ADDENDUM NO. 2

Project Name: Fairgrounds AG Pavilion Roof Coating

ITB Number: 2024040

ROOF DECK PLAN

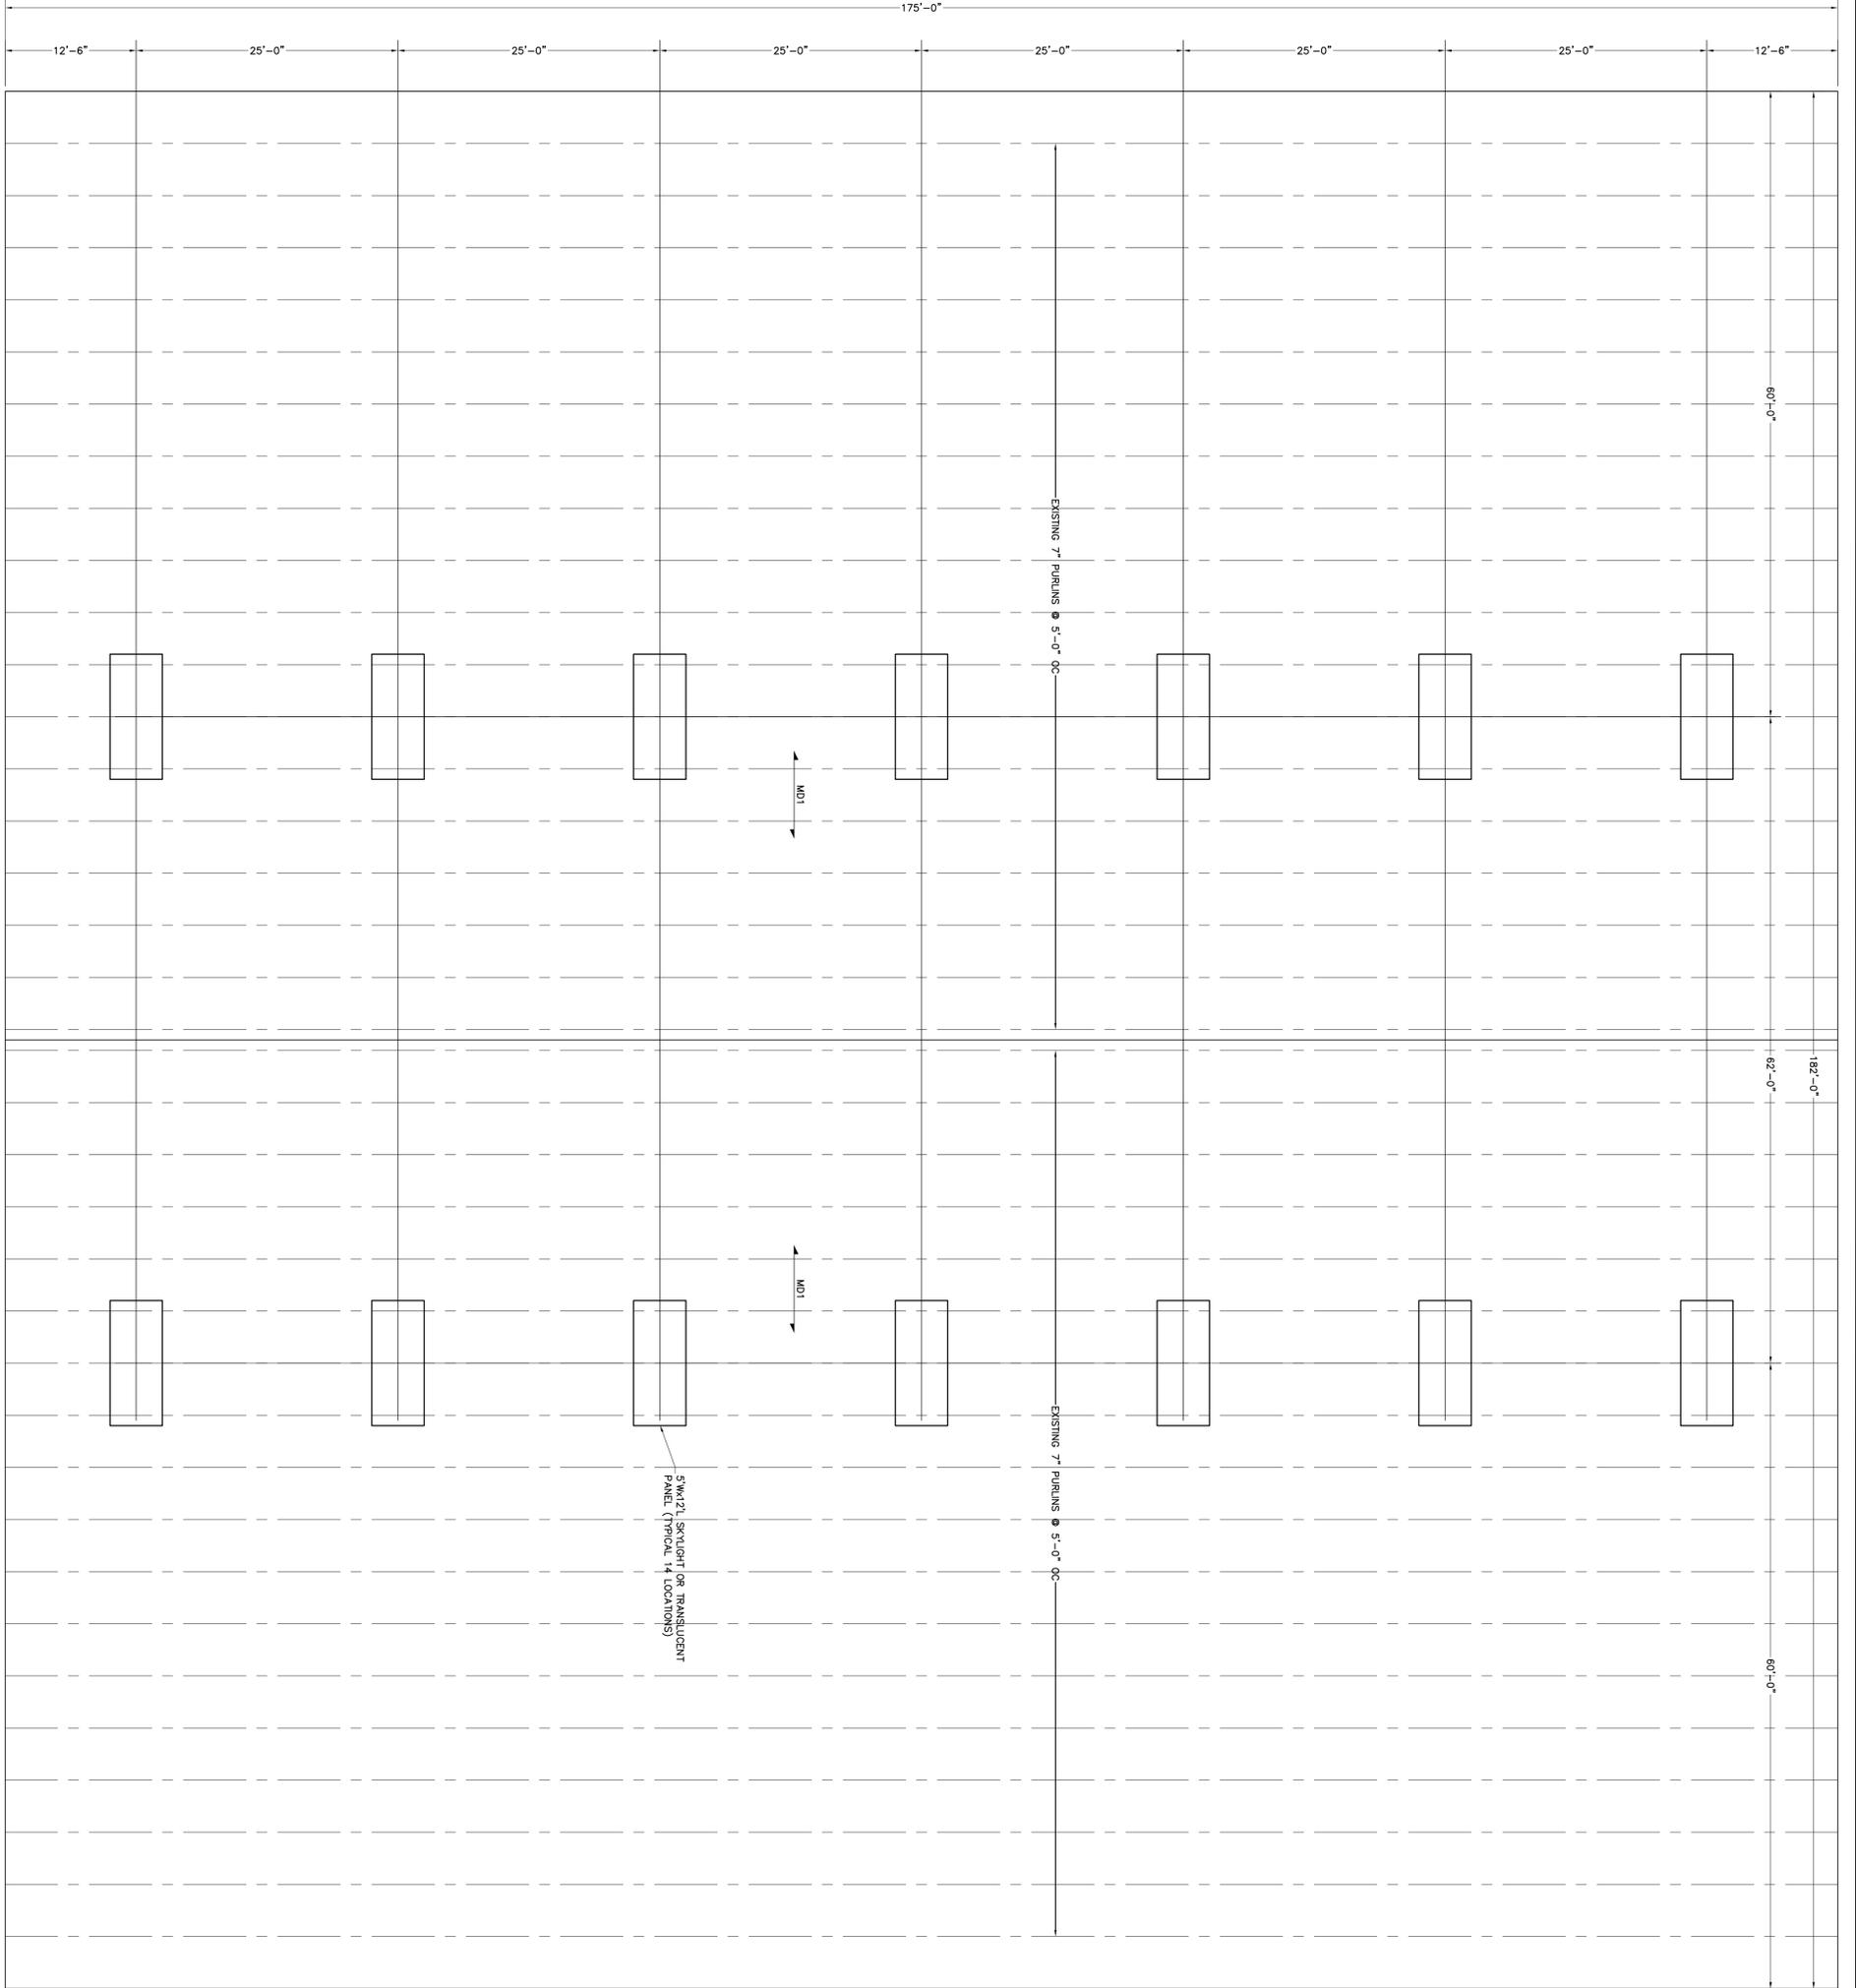
1.	Can you please release a specification for any product(s) that will provide a 15-year warranty? The County has no specification to release.
2.	Is there an engineer's estimate for this project? Estimate is \$85,875
3.	Will you consider other products and procedures before, and, or after time of award? See response to question 19.
4.	What is the base / ground of the pavilion? (dirt, gravel, concrete?) Dirt
5.	Will you provide a specification for the waterproofing of the fasteners? #9400 Eterna-Sil Premium Silicone Mastic or similar
6.	Can you provide a specification for the fasteners? No specification is available.
7.	Can you provide a specification for the coating that is already on the roof? Metal panels are only coated with the factory paint
8.	Will you provide drawings of the overhead lighting replacement?

For Skylight replacement see attached roof deck plan.
9.	When was this pavilion built?
	This pre-engineered metal structure was originally constructed in 1986, with some modifications completed in 1991.
